HARBOR BROOK TREATMENT WETLANDS CSO STORAGE

CONTRACT NO. 1 - GENERAL

ONONDAGA COUNTY DEPARTMENT OF WATER ENVIRONMENT PROTECTION SYRACUSE, NEW YORK

RECORD DRAWINGS

CIVIL
 OVERALL PLAN

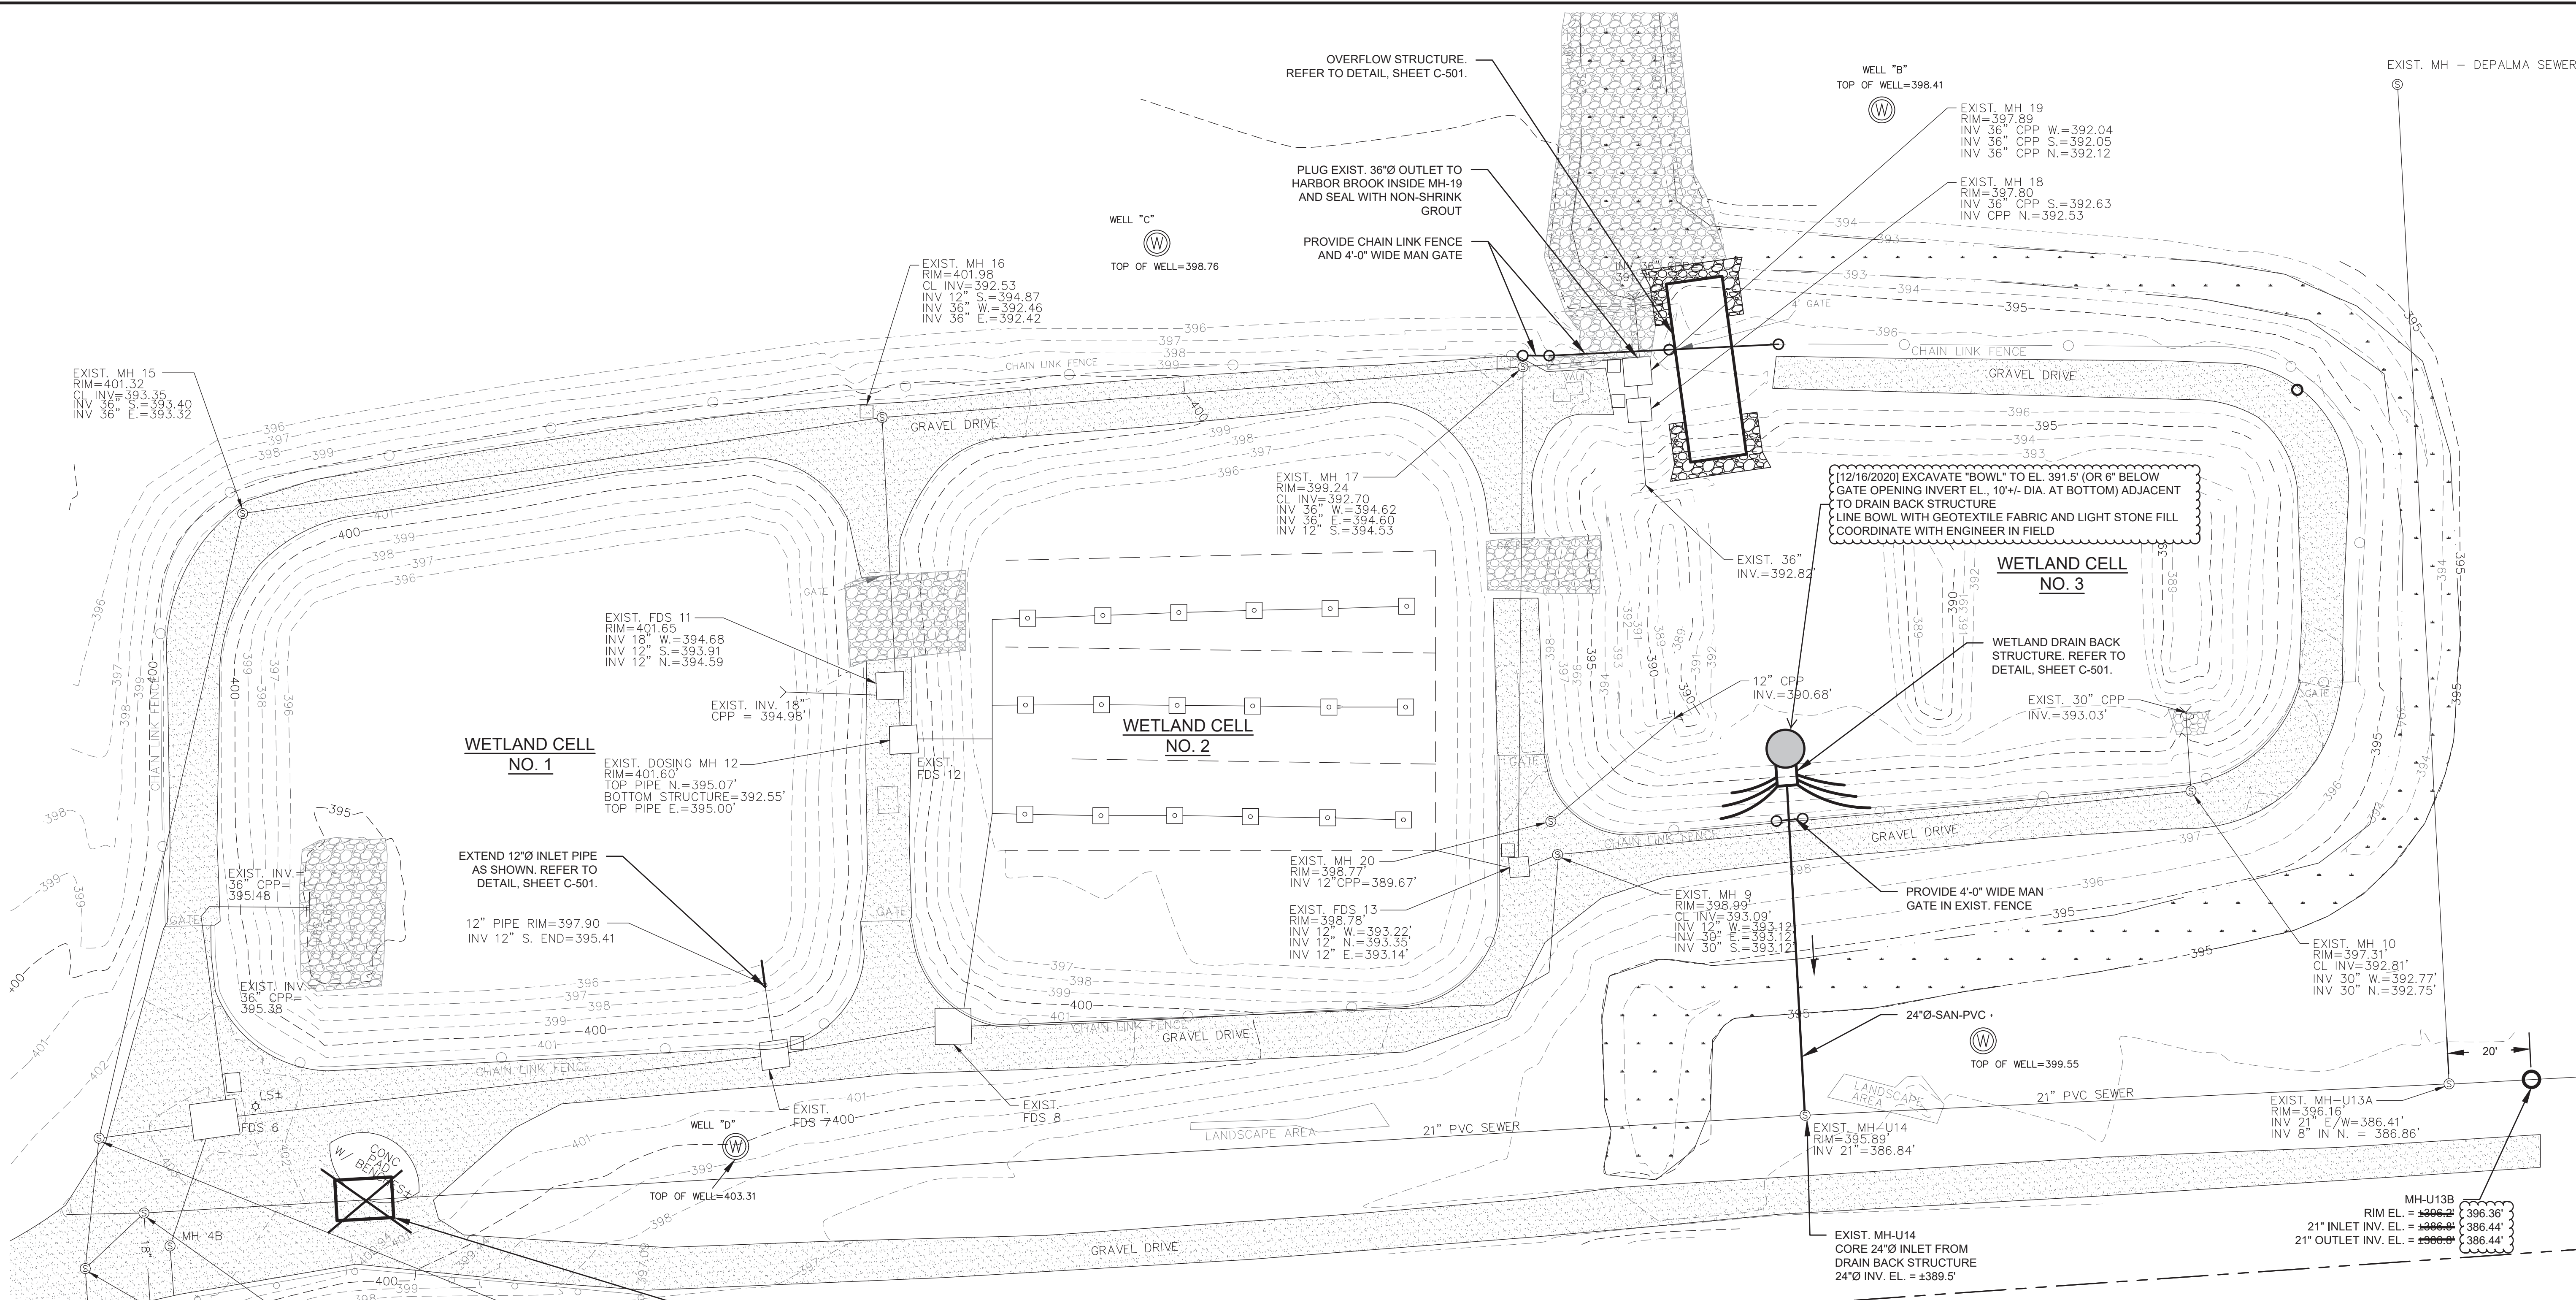
(12/16/2020) EXCAVATE "BOWL" TO EL. 391.5' (OR 6" BELOW GATE OPENING INVERT EL., 10'+/- DIA. AT BOTTOM) ADJACENT TO DRAIN BACK STRUCTURE. LINE BOWL WITH GEOTEXTILE FABRIC AND LIGHT STONE FILL. COORDINATE WITH ENGINEER IN FIELD.

- On Sheet C-101, ADD the following Drawing Note:
 "1. MAINTAIN, SUPPORT AND PROTECT EXISTING 21" PVC SEWER PIPE DURING INSTALLATION OF PILES AND CONCRETE PILE CAP FOUNDATION. CUT AND REMOVE EXISTING PIPE AS REQUIRED TO INSTALL MH-U13B. PROVIDE NEW PVC PIPE AS REQUIRED TO CONNECT EXISTING PIPING TO STRUCTURE. PROVIDE TEMPORARY BYPASS PUMPING AS SPECIFIED."

GRIT CHAMBER CENTER ON EXIST. SEWER PIPE. REFER TO STRUCTURAL DRAWINGS.
 GRIT CHAMBER ELIMINATED BY MODIFICATION NO. 1, 6/10/2021

(COORDINATES REVISED PER RFI-07 RESPONSE, 11/4/2020)

GRIT CHAMBER FOUNDATION PLAN

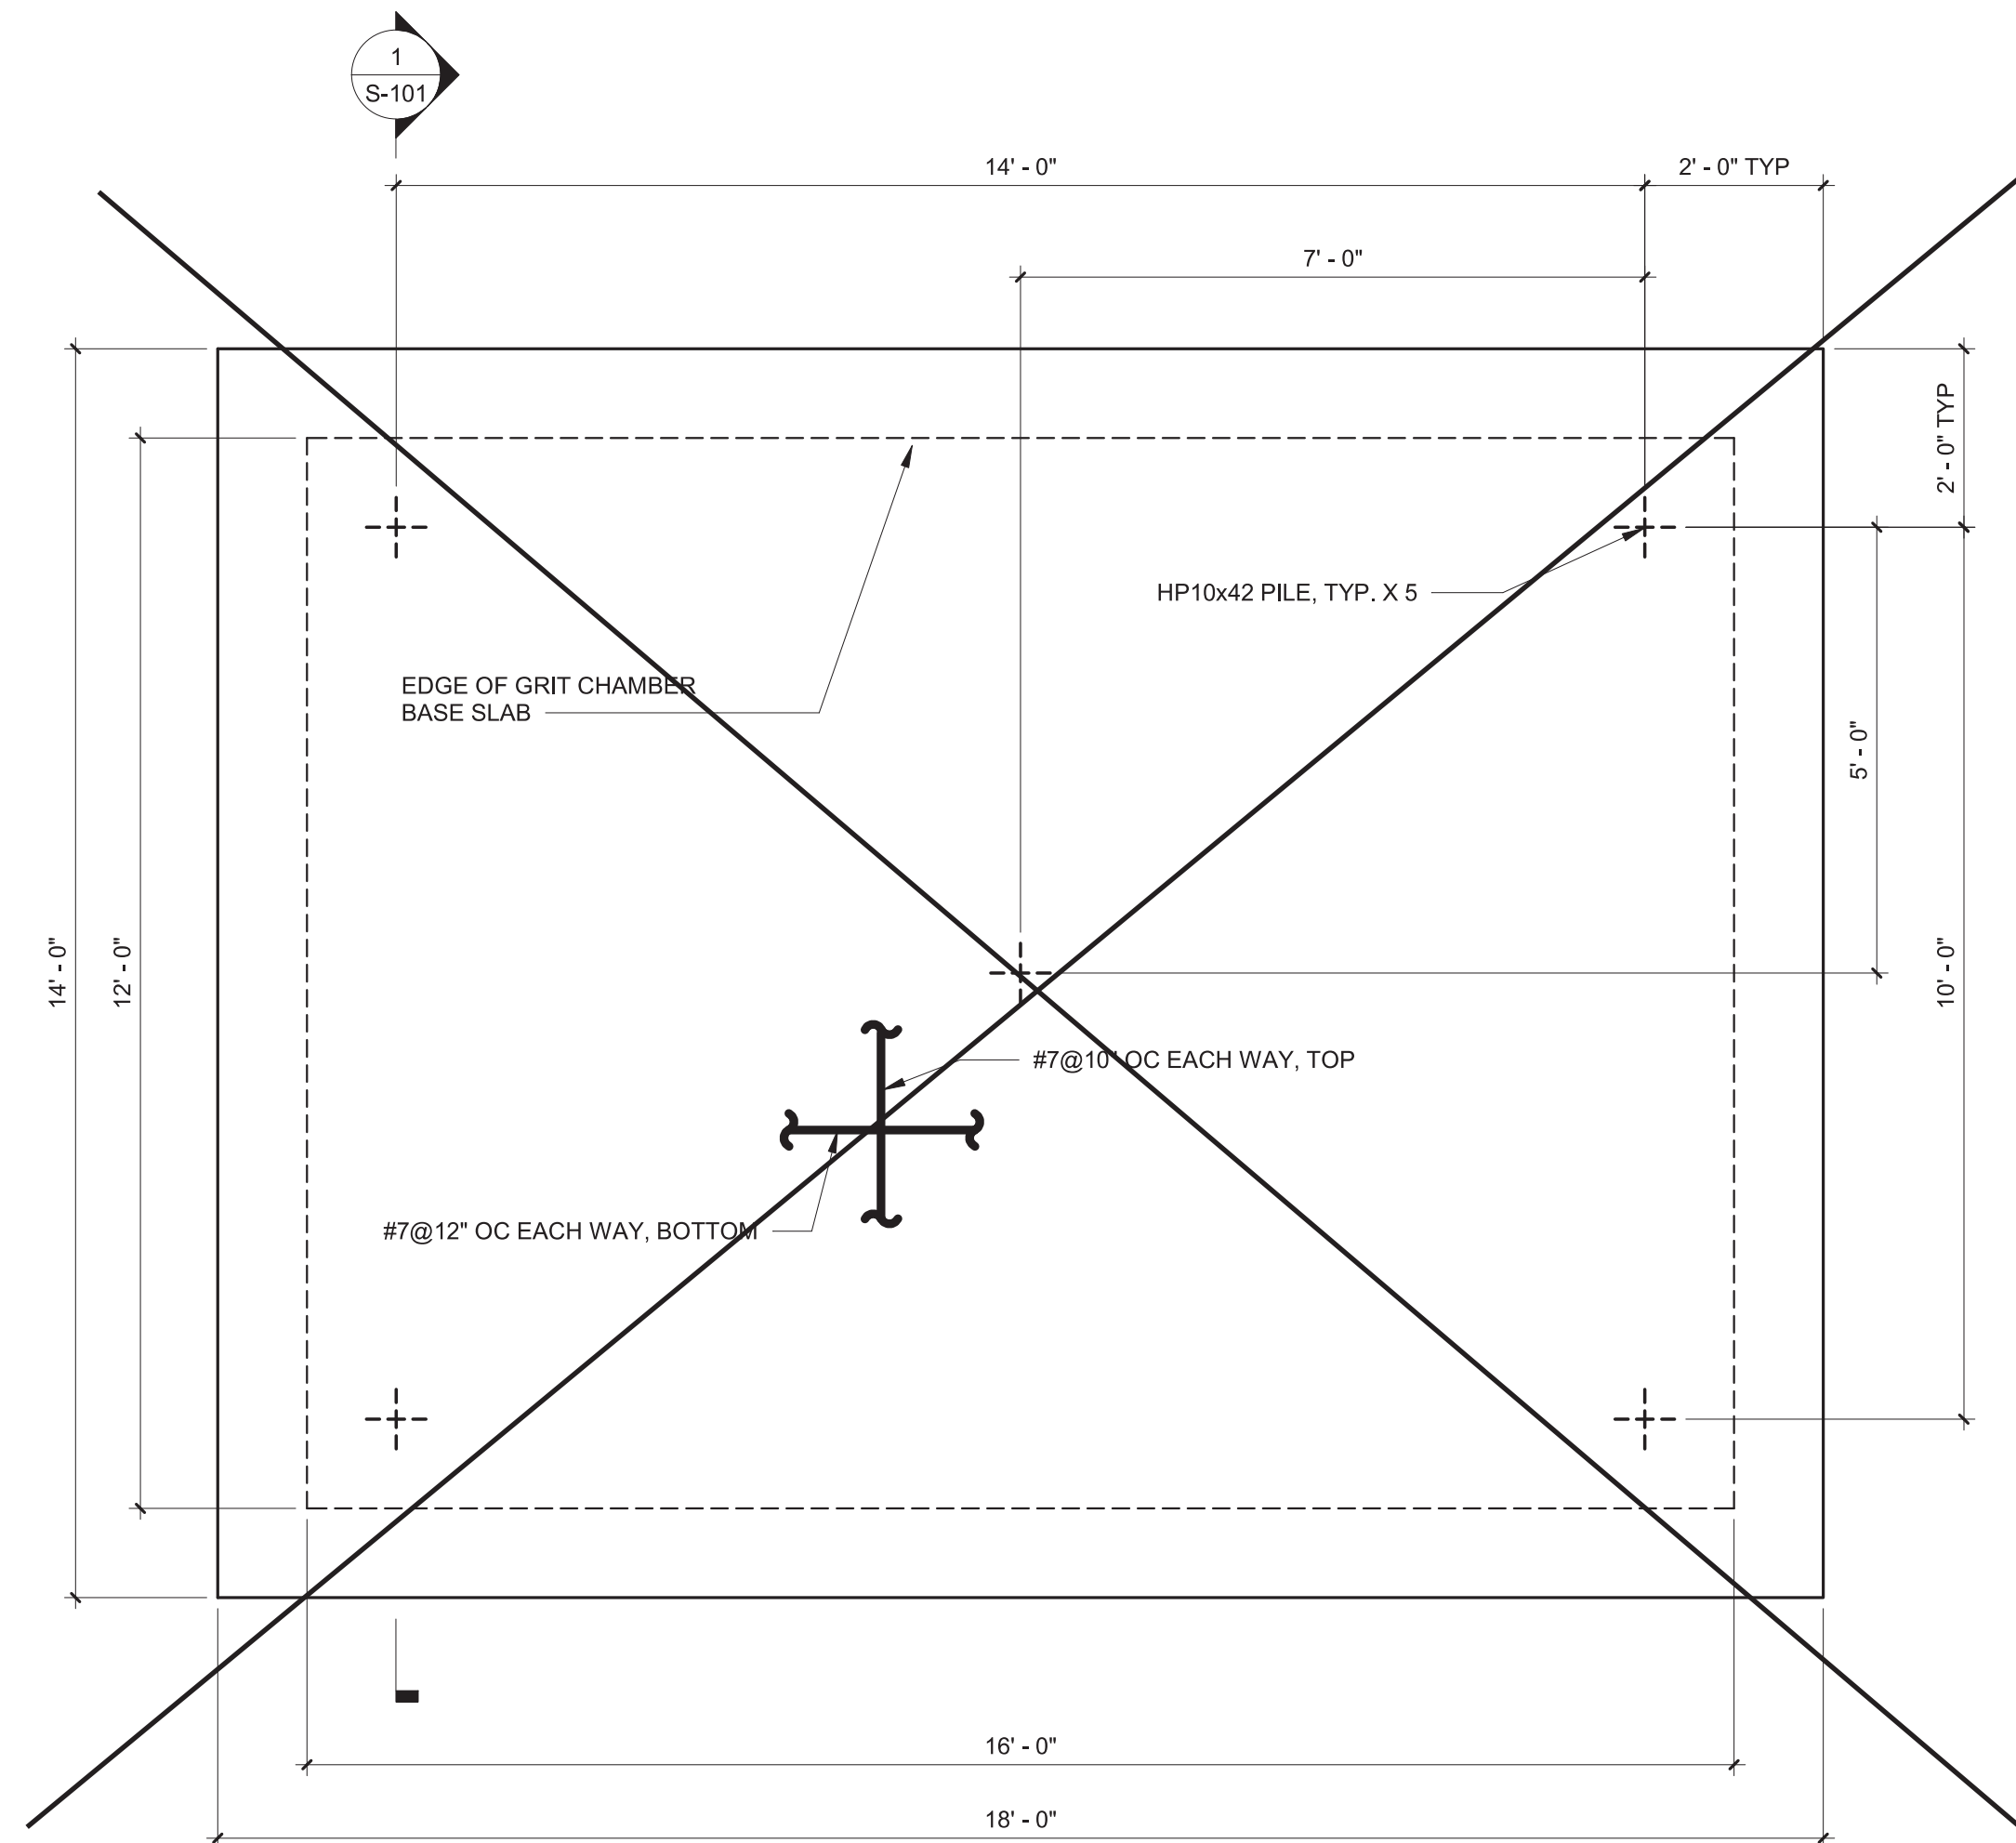
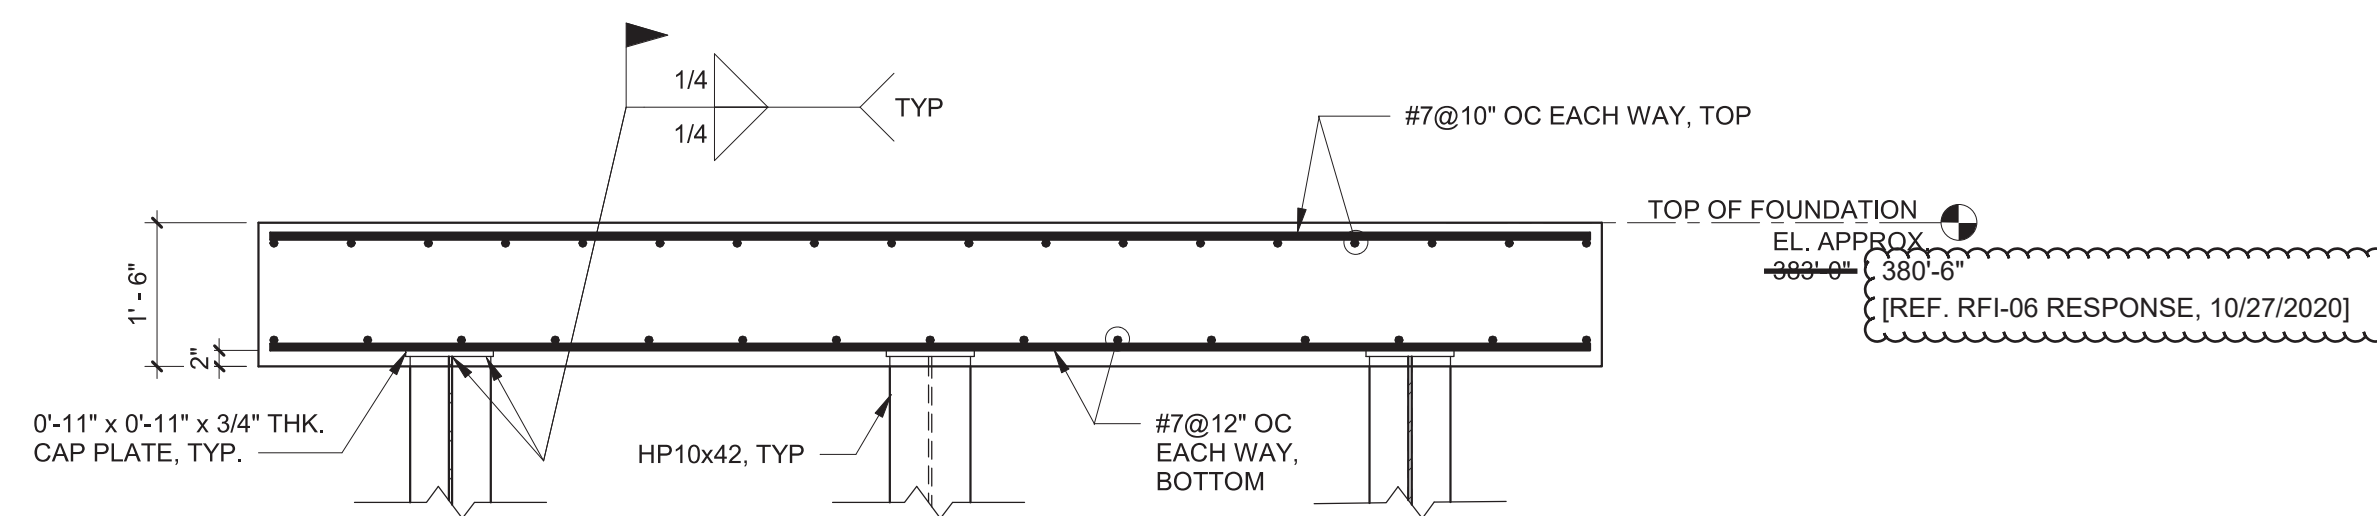
GRIT CHAMBER ELIMINATED BY
MODIFICATION NO. 1, 6/10/2021
